Product Change Notification / SYST-24YYJU400

ERRATA - AVR128DB28/32/48/64 Silicon Errata and Data Sheet Clarifications Errata Document Revision

AVR128DB28/32/48/64

Silicon Errata and Data Sheet Clarifications

Figure 34-1. DAC Block Diagram

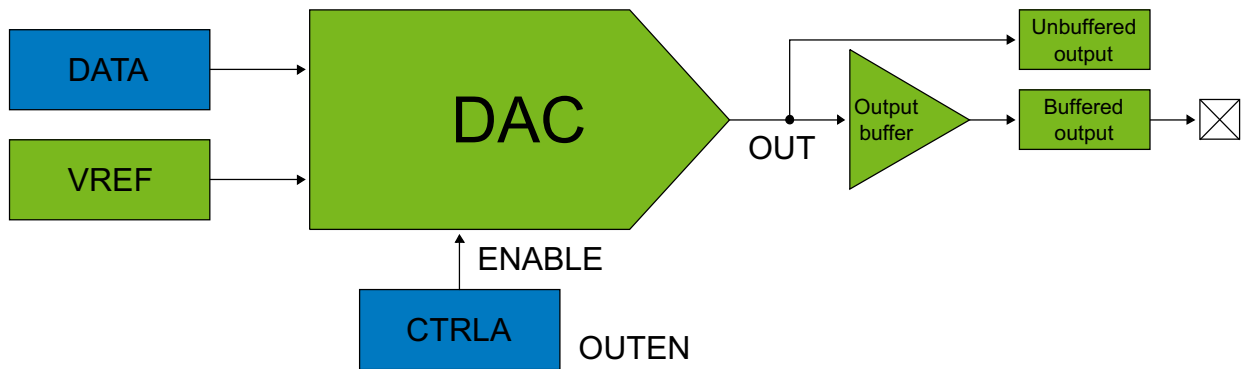
3.5.1 DAC Output

Clarifications of the block diagram and the DAC Output sub-section of the DAC peripheral has been made:

1. The block diagram is updated with clarifications to the output signal routing (buffered/unbuffered) and will replace the original block diagram.
2. Sections 34.3.2.3 (DAC as Source For Internal Peripherals) and 34.3.2.4 (DAC Output on Pin) are replaced by section 34.3.2.3 DAC Output.

Figure 3-1. I_{DD} Over V_{DD} and Temperature With IRSEL = 0

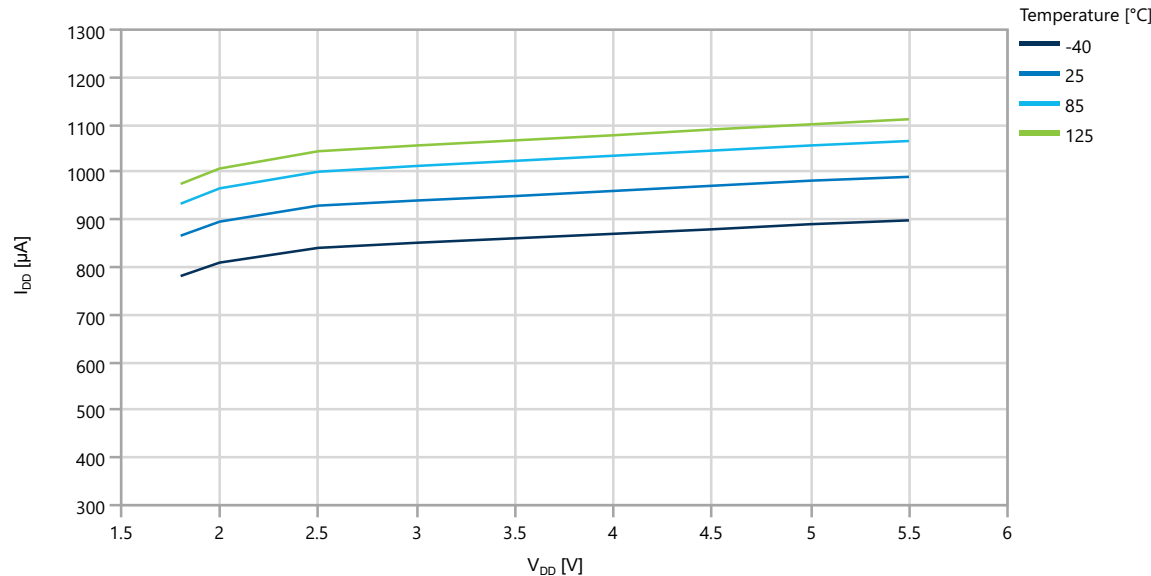
Some additional plots are added to the OPAMP section of the Typical Characteristics:

- I_{DD} over V_{DD} and temperature with IRSEL = 0
- I_{DD} over V_{DD} and temperature with IRSEL = 1
- Output sinking short-circuit current over V_{DD} and temperature
- Output sourcing short-circuit current over V_{DD} and temperature
- Output impedance over frequency at 3V and 25°C
- Small-signal non-inverting pulse response at 3V V_{DD}
- Large-signal non-inverting pulse response at 3V V_{DD}

Note: This plot is only valid for revision A5 and later.
